Supporting Planning Statement And Addendum to Flood Risk Assessment

**s73 Application for Variation of a condition
following planning consent 136320/FH/2023**

Ashfield Lodge Bungalow, 227 Palatine Rd, Manchester M20 2UD

Figure 2: charred timber cladding

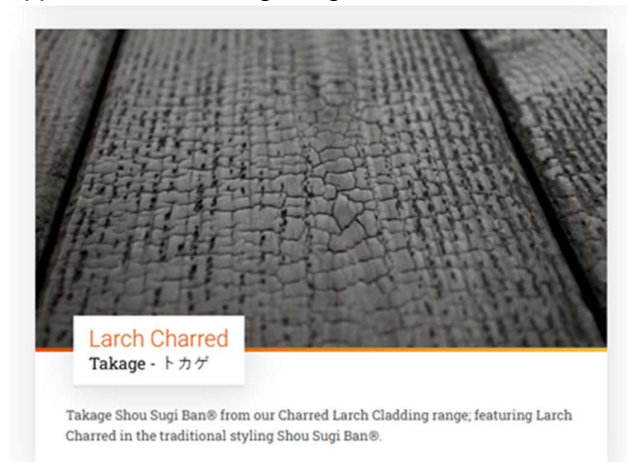
It is proposed to change the wall finish from brick to a combination of charred wood cladding, stone cladding and silicone render in a similar shade to the stone cladding. Windows, doors, fascias will change from white to grey. The change of materials also applies to the existing bungalow to match the new extension.
